August 12, 2016
File No. 14-032.200

**Subject: Geotechnical Report Addendum
Evaluation of Surcharge Load on the Soldier Pile Wall
Proposed Single-Family Residence
4634 E Mercer Way, Mercer Island, WA**

4634 E MERCER WAY
SOLDIER PILE WALL SECTION

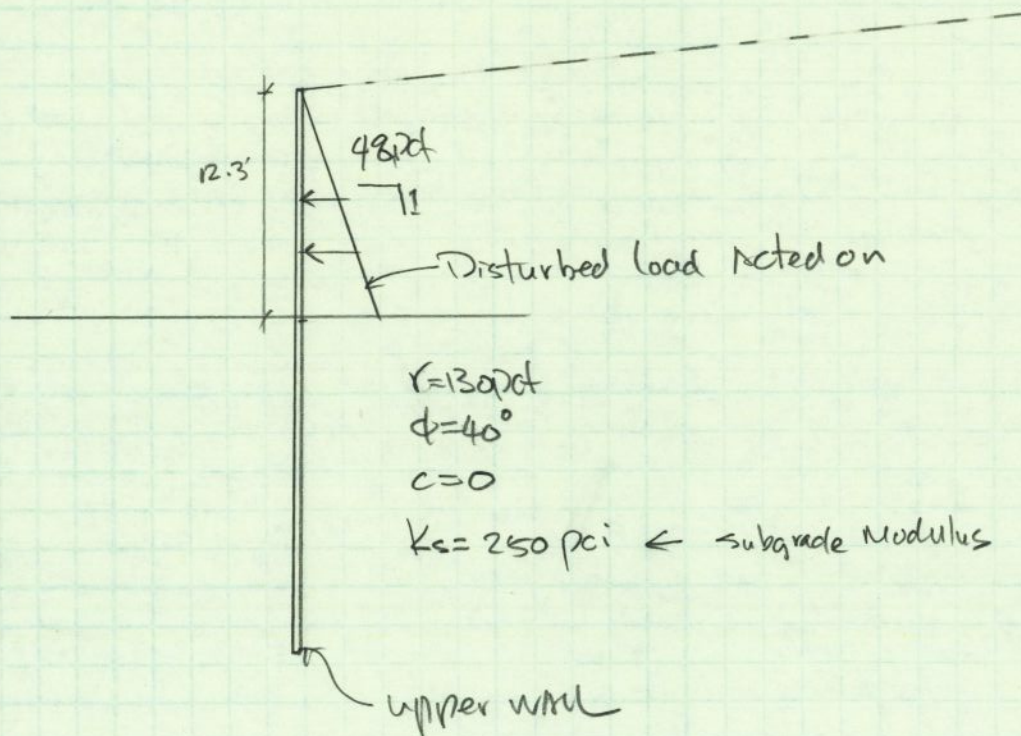
Based on the current design plans, the upper and lower walls are spaced approximately 15 feet (see attached page 1). We selected a critical upper wall section with a height of 12.3 feet for our analysis (see page 2). Soil parameters are assigned based on the subsurface data for L-Pile analysis. We then performed L-Pile analyses to obtain the point of fixity of the soldier piles. The summary results of L-Pile analyses for the 12.3 feet and 8.9 feet high upper wall are included on pages 3 and 4 of the attachment. Based on the lateral pile analysis, the point of the fixity of the soldier pile is found to be at 23.8 feet for the 12.3 high wall section and 19.3 feet for the 8.9 high wall section. Based on the point of fixity, the approximate passive wedge of the upper wall is plotted on page 1, and it appears the passive wedge intercept the very top of the lower wall (approx. upper 1.6'). As a result, there will be some surcharge load on the lower wall due to the passive wedge of the upper wall.

In summary, based on results of our analysis, there is likely small surcharge near the top of the lower wall due to mobilization of the passive wedge of the upper wall. To account for the impact of this surcharge due to upper wall passive pressure, we recommend to increase the active earth pressure of the lower wall 15% for the soldier pile design in areas it has a parallel upper soldier pile wall. It is our opinion that this simplified and conservative approach should be adequate to account for the potential impact of the upper wall on the lower wall.

Figure 10.7.2.4-1—Definition of Loading Direction and Spacing for Group Effects

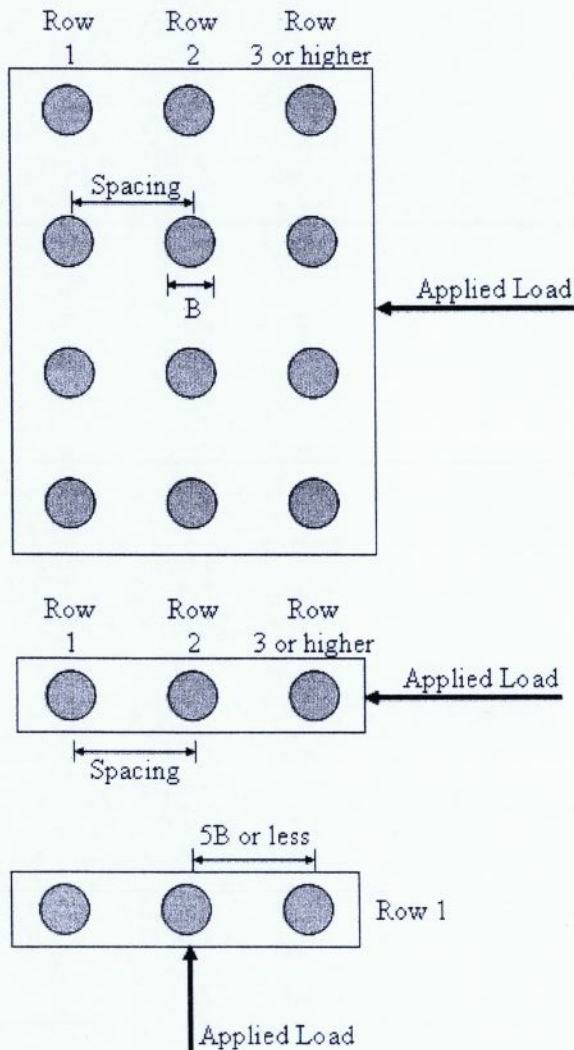
As an attempt to quantify this surcharge load, we reviewed AASHTO bridge design specification and other documents. According to AASHTO, the group effect for 2nd row for a pile spacing of 5 times the pile diameter is 0.85 (see page 5). The spacing between upper and lower walls are about 6 times the soldier pile diameter. As such, the group effect factor will be between 0.85 and 1. Page 6 of the attachment also shows that the moved/disturbed soil in front of the pile is approximately ellipse in shape in plan view.
